**AMENDMENT NO. 4 TO THE  
TENDER DOCUMENTS**

**PROJECT TITLE:** Fire System Replacement, B052  
Trenton, Ontario

## Addendum No. 01

**Project** TRE-UPG B052 (HGR 10) FIRE PUMPHOUSE

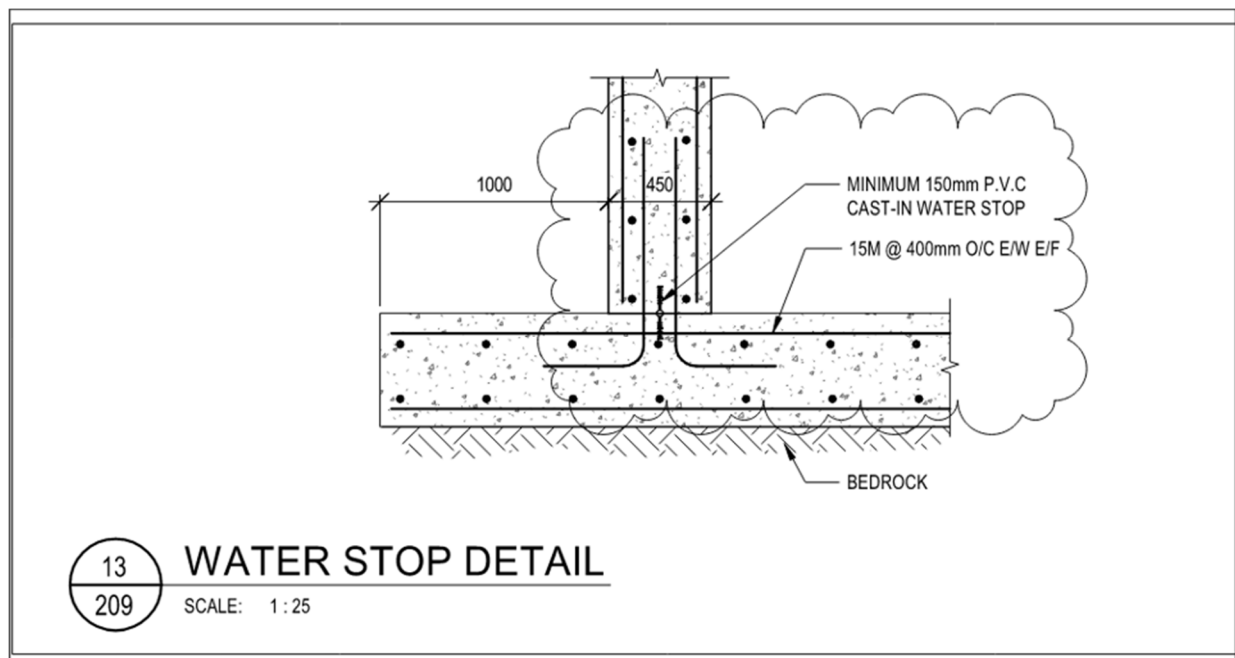
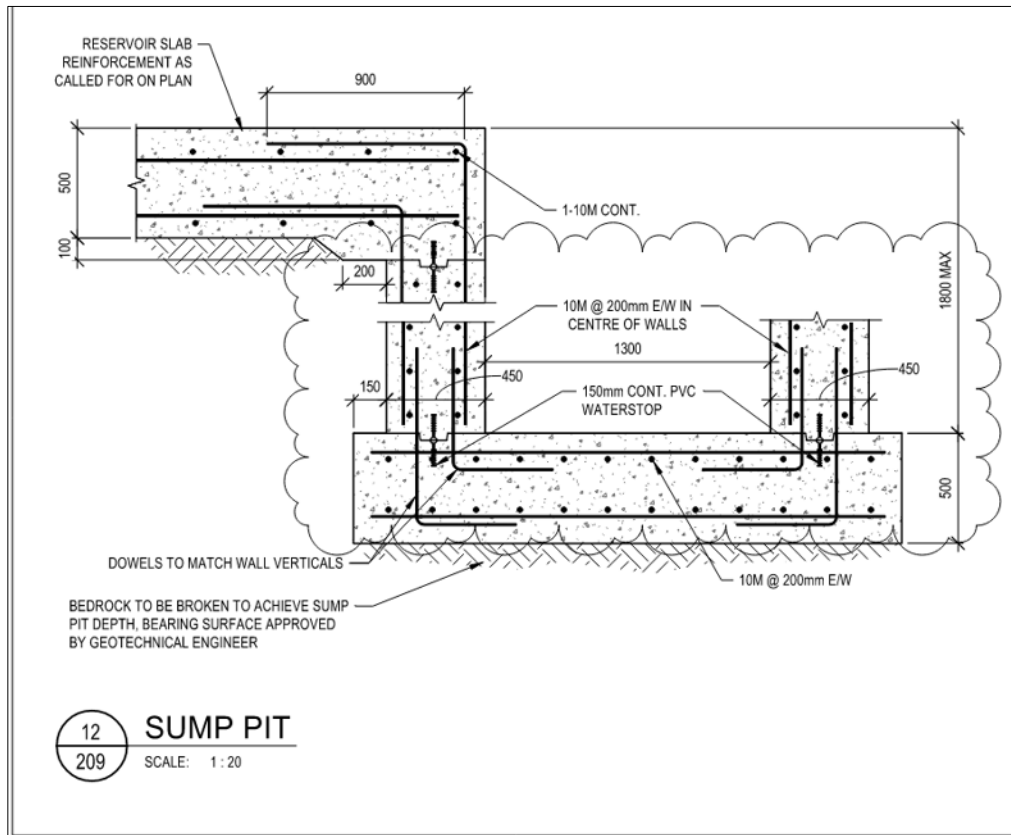
##### .1 Detail 1 – Changed sloped insulation percentage and water proofing notes. Concrete slab to be flat.

#### 1.4 Drawing 210 – Details Cont.

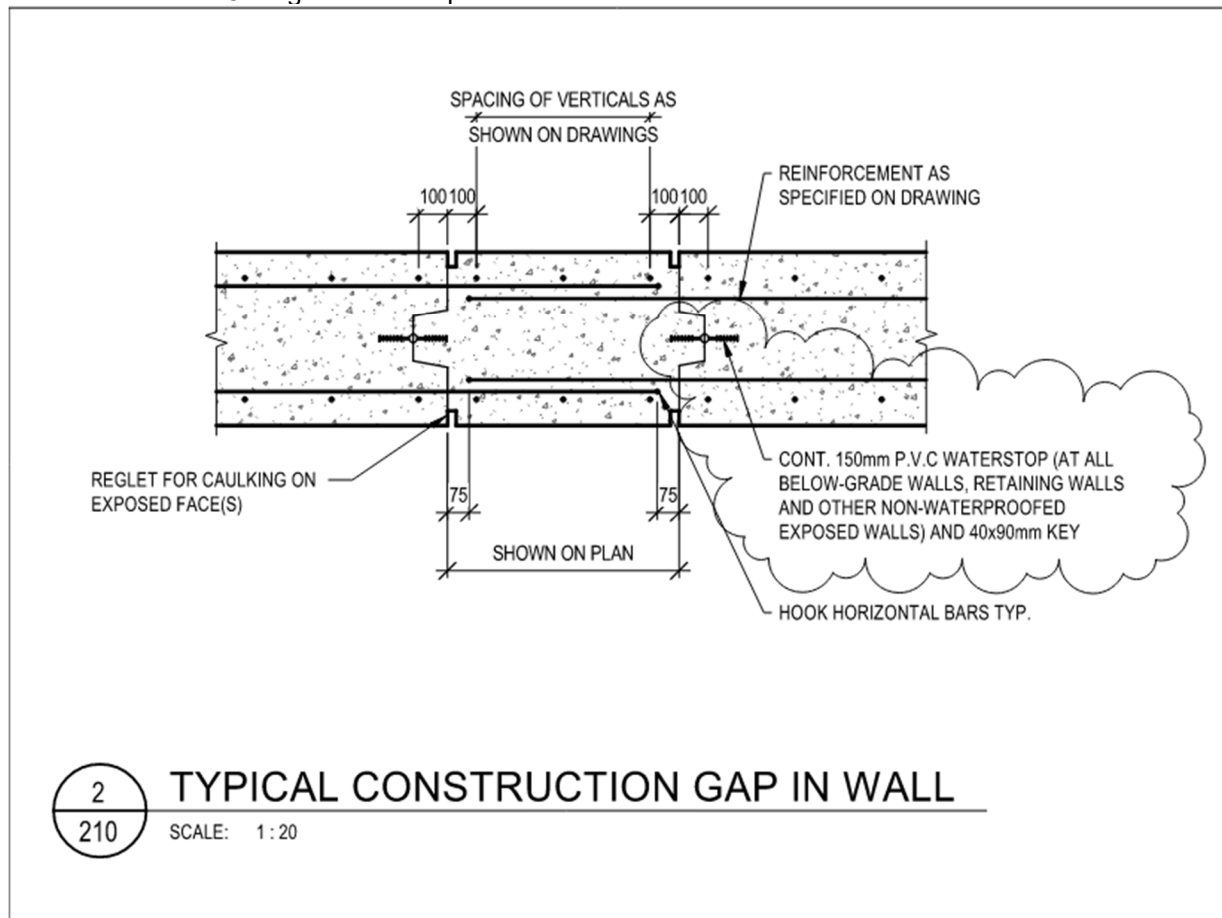
##### .1 Detail 2 – Changed water stop size.

#### 1.5 Drawing 401 – Legends, Schedules & Drawing List

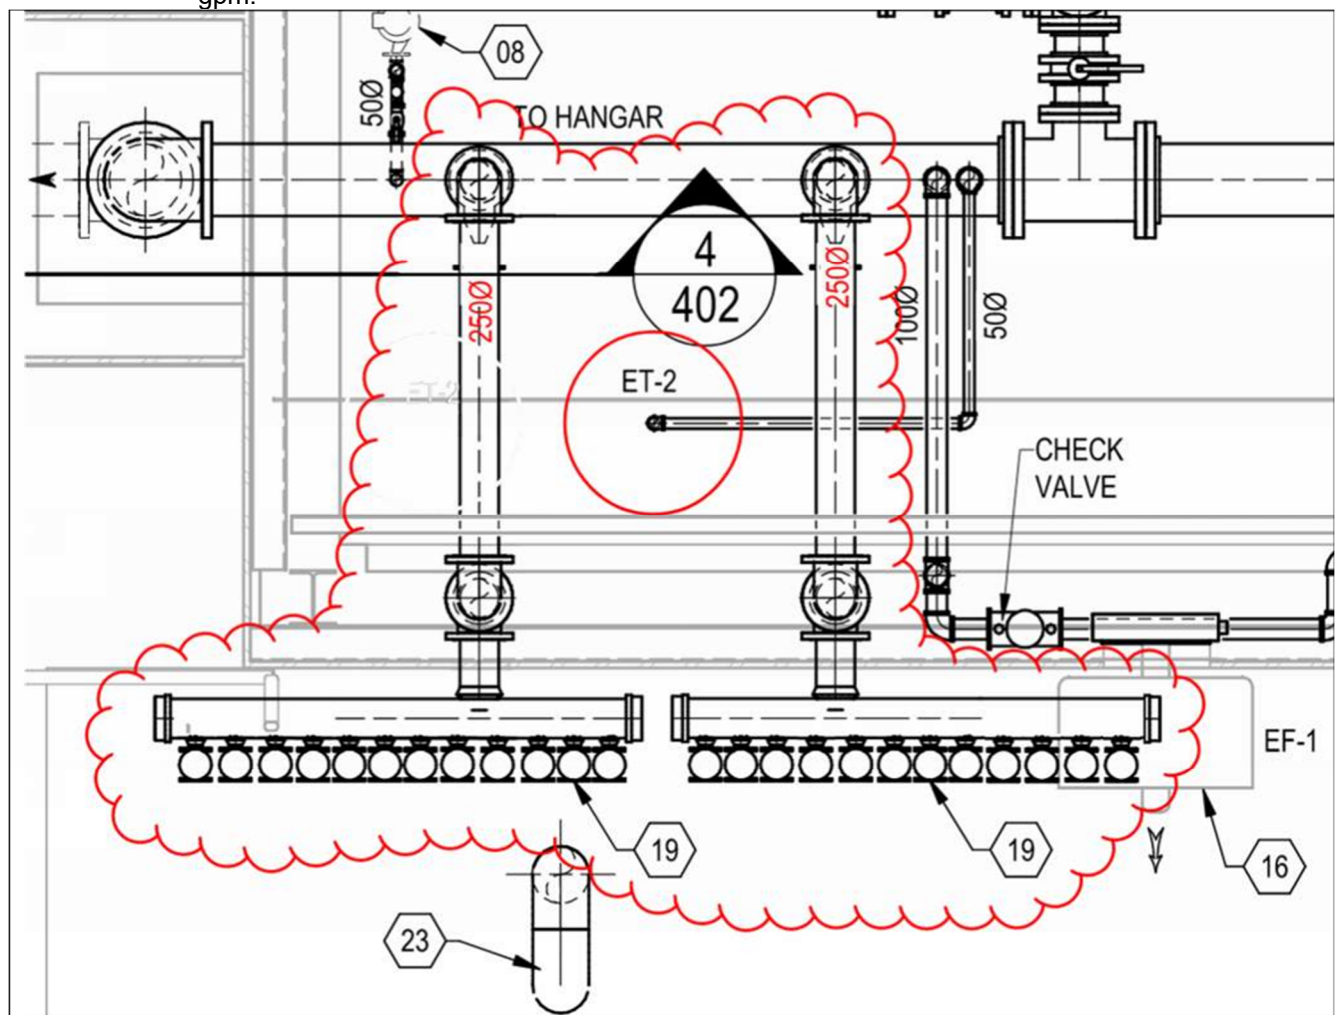
##### .1 Delete Area of Work hatch over Building 57 and reference to Drawing 404.

.2 Add two (2) general notes on this drawing.

- 04 The red-painted pipes above the slab in the sprinkler valve stations are assumed to contain lead. Contractors shall include the required health and safety measures, as well as any associated handling, removal, and disposal costs, in their quotations.
- 05 Maximum allowable downtime of the existing fire suppression in Hangar 10 to permit the below-slab pipe replacement work is 6 weeks (consecutive). Contractors shall make provisions to ensure fire suppression is back online, either permanently or temporarily until final tie-ins/commissioning can be completed for the new supply, within this timeframe.

## 1.8 Drawing 406 - Hangar 10 Existing Water Main Valve Off

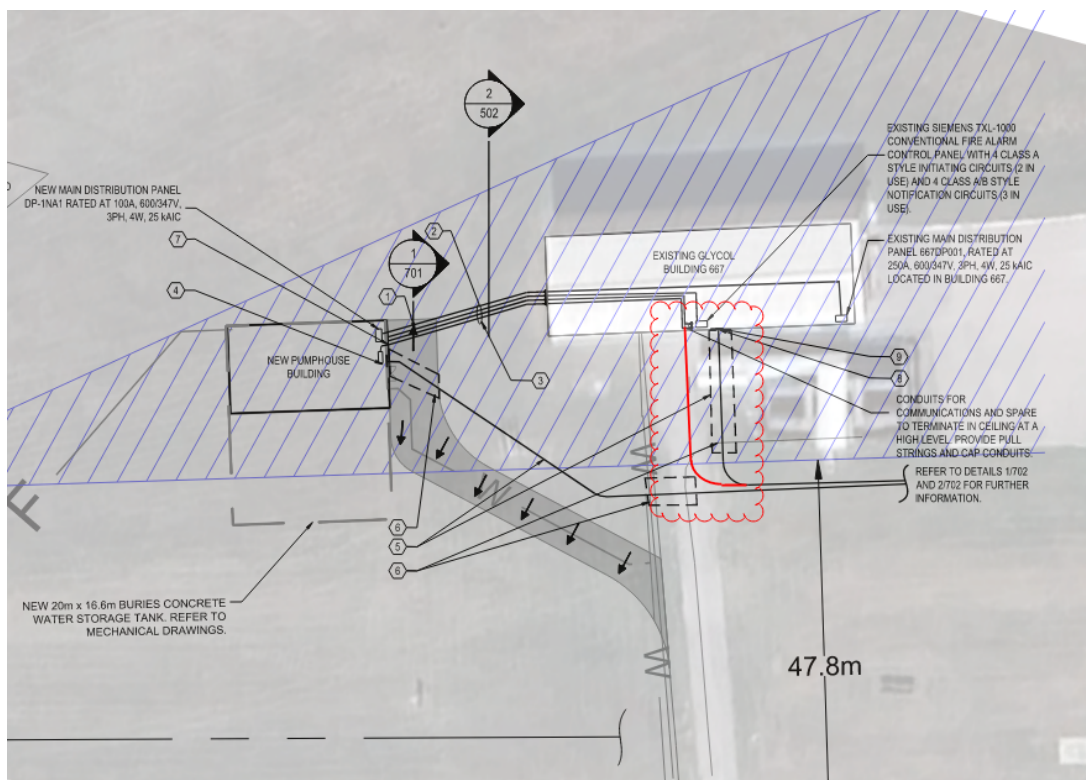
- .1 Replace this drawing in its entirety with the attached Drawing 406 – Hangar 10 Existing Water Main Valve Off, dated August 7, 2026.
- .1 Revisions are identified by revision clouds (bubble areas).

## 1.6 Drawing 402 – Fire Protection Plans

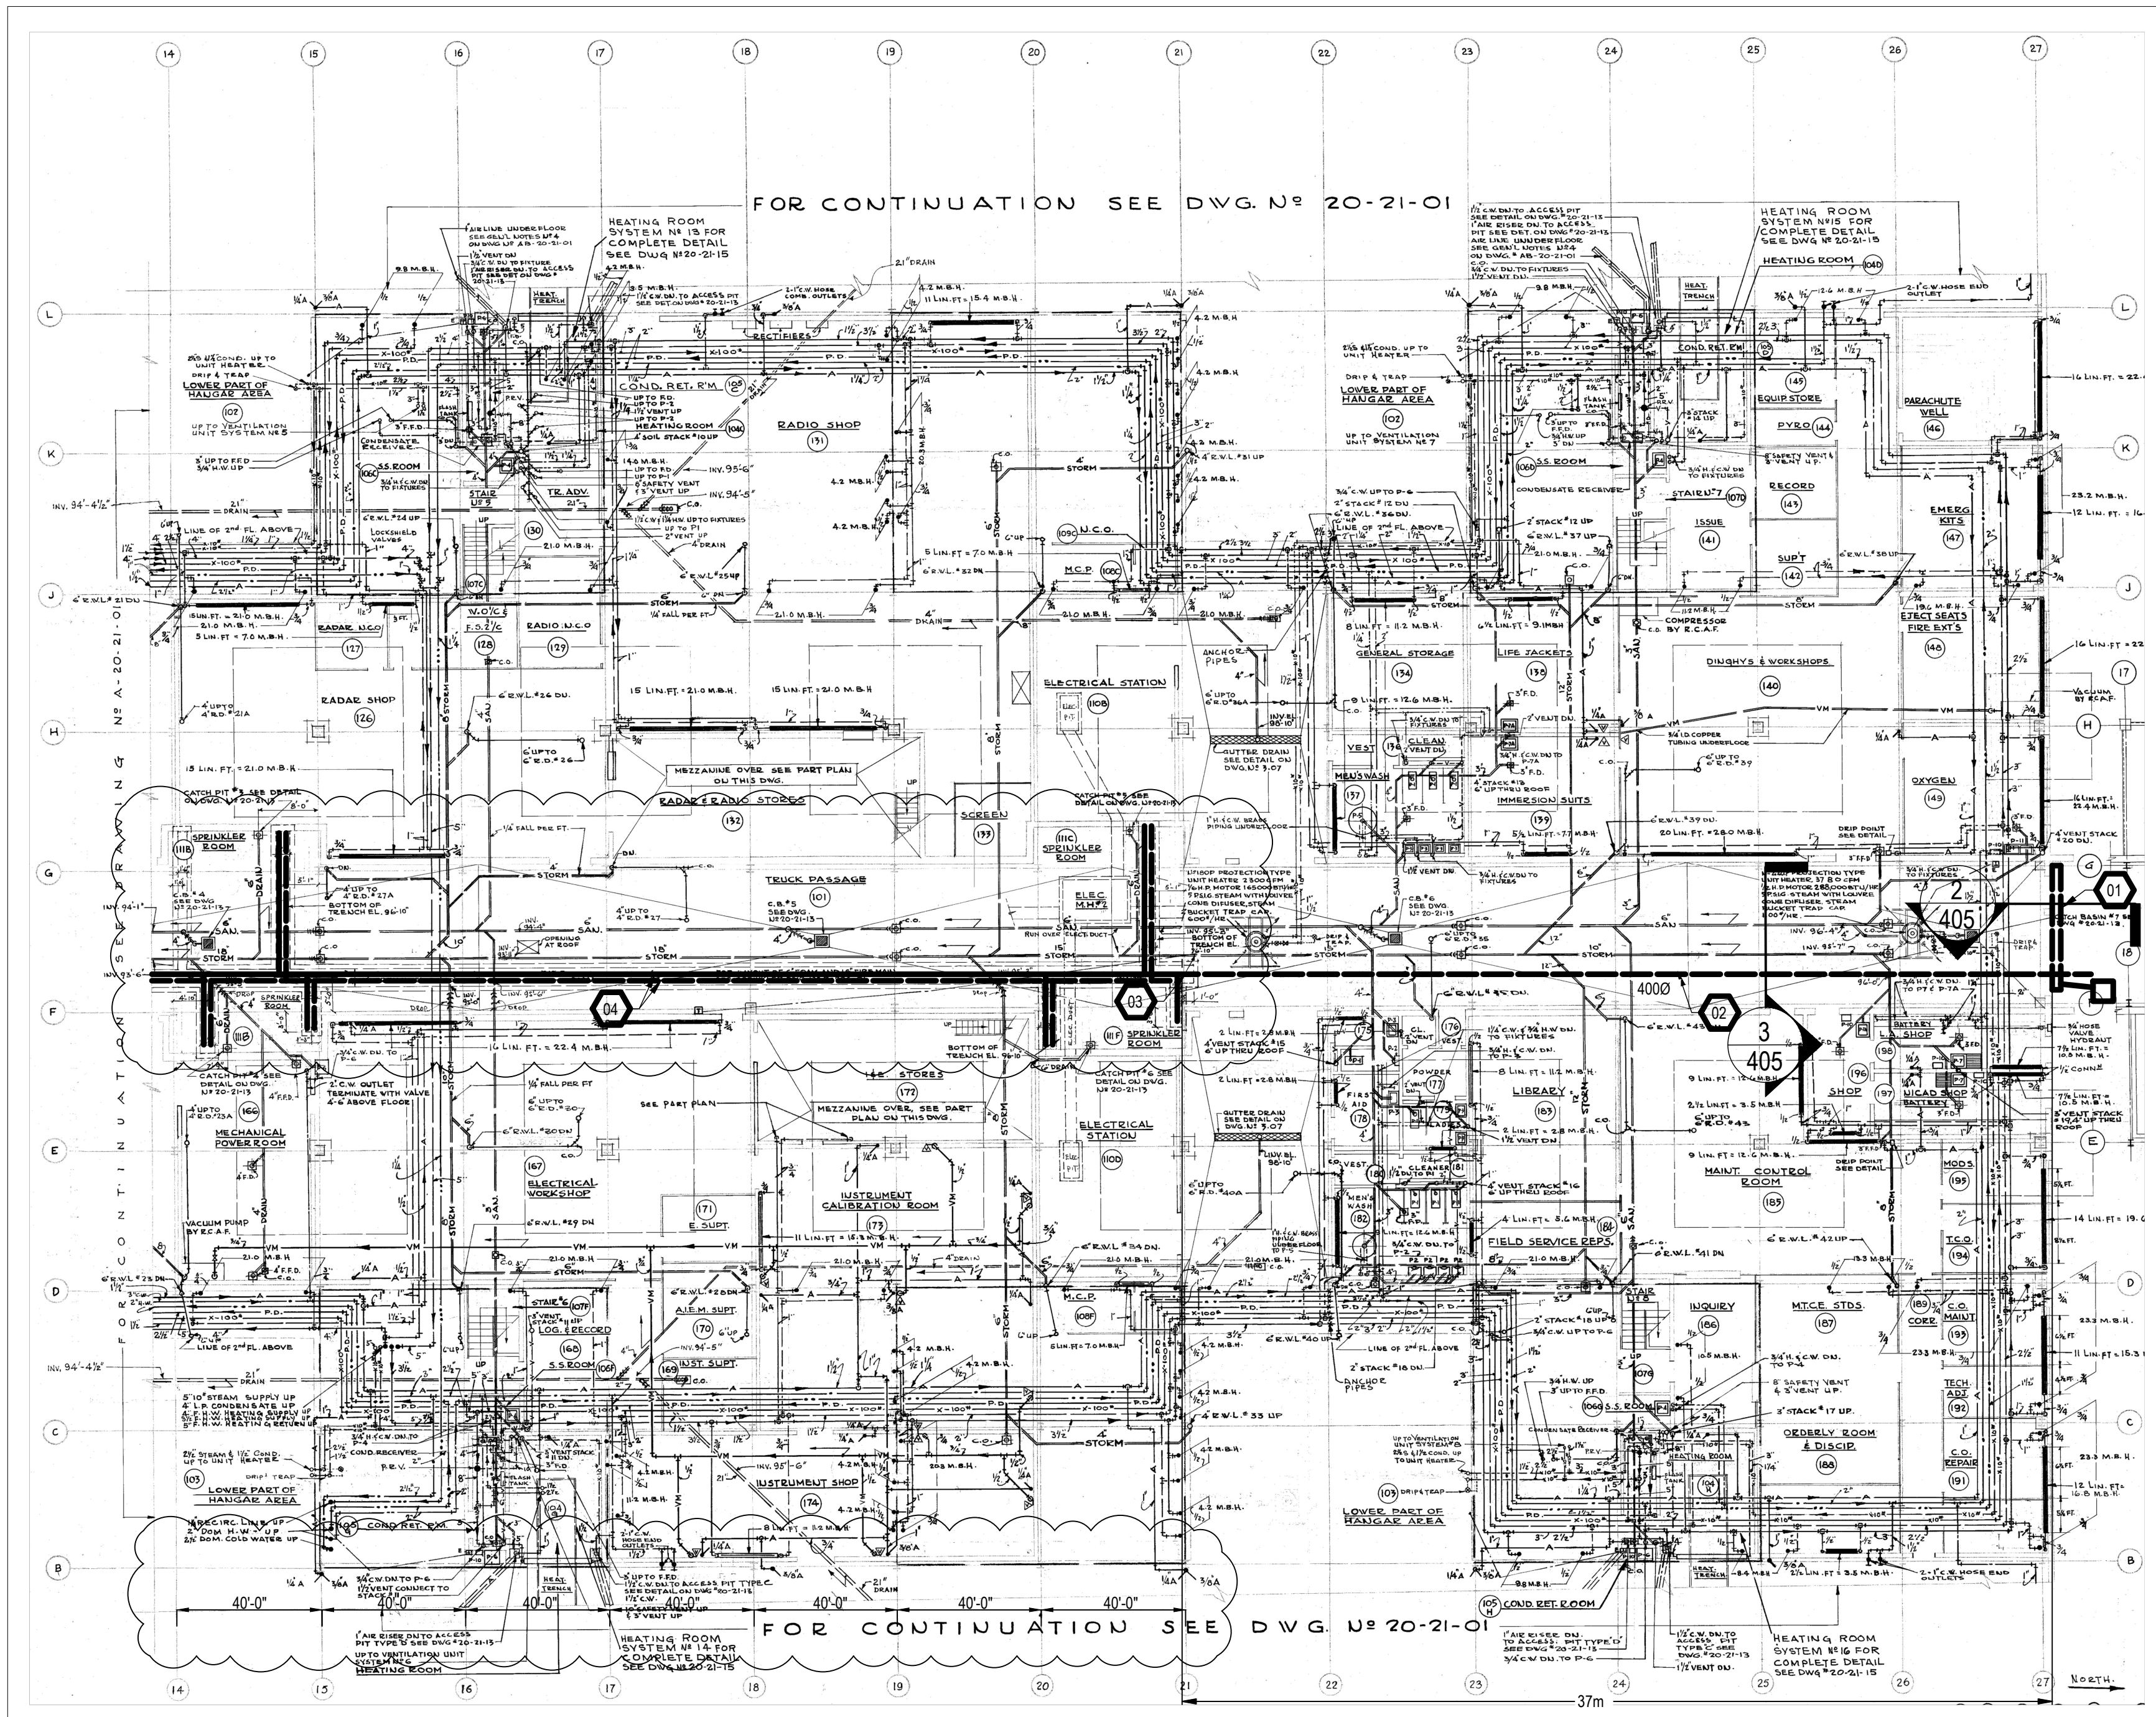
- .1 Revise Drawing Note 19 as follows: “Provide 250mm test header with twelve (12) 65mm hose connections and two (2) non-threaded connections.”.
- .2 Provide second test header as shown in the sketch below for total capacity to 6,000 gpm.

2  
506 FIRE ALARM RISER DIAGRAM - PUMPHOUSE BUILDING  
SCALE: N.T.S.

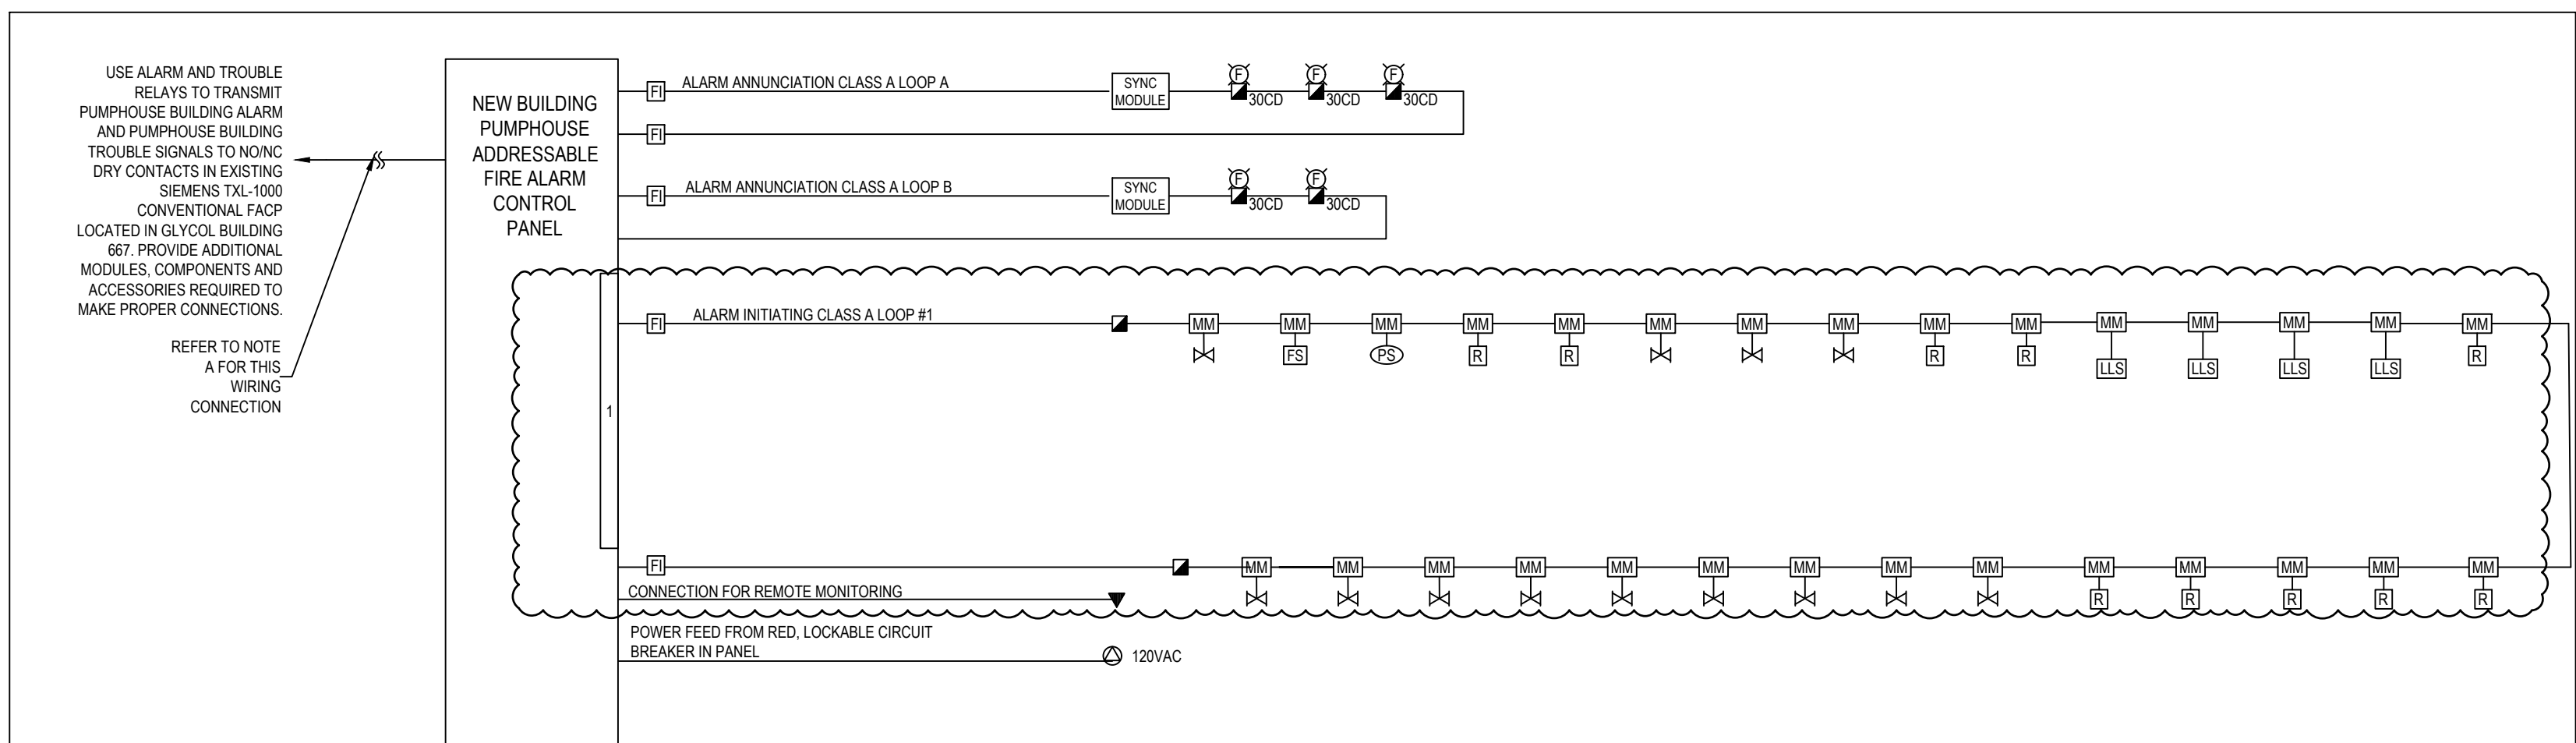
- .1 All fire alarm wiring shall be FAS 105 type in accordance with FMD 4003.
- .2 Fire alarm zone schedule provided.
- .3 Detail 2 Fire Alarm Riser Diagram – Pump House Building
  - .1 Fire alarm riser schematic revised to show DCLC wiring between the Pump House and Glycol Building 667, complete with isolation modules, grounding and surge protection.
  - .2 Fire alarm riser schematic revised to show Class A loops for alarm annunciation.
  - .3 Fire alarm load summary table updated and reference to manufacturer names deleted.

- FOR THE CONNECTION BETWEEN THE NEW PUMPHOUSE BUILDING AND THE EXISTING GLYCOL BUILDING PROVIDE DCLC WIRING WITH FAULT ISOLATOR MODULES IMMEDIATELY BEFORE ENTERING AND AFTER EXITING EACH BUILDING. GROUND CABLE SHIELD AT MAIN FIRE ALARM CONTROL PANEL ONLY. PROVIDE FIRE ALARM-RATED SURGE PROTECTION AT BOTH BUILDING ENTRY POINTS, BONDED TO THE BUILDING GROUNDING SYSTEM. INSTALL WIRING IN A DEDICATED RACEWAY SEPARATE FROM POWER CIRCUITS. INSTALL TEST AND VERIFY IN ACCORDANCE WITH CANULC-S524 AND CANULC-S536. COORDINATE ALL WIRING REQUIREMENTS WITH THE FIRE ALARM SYSTEM MANUFACTURER.
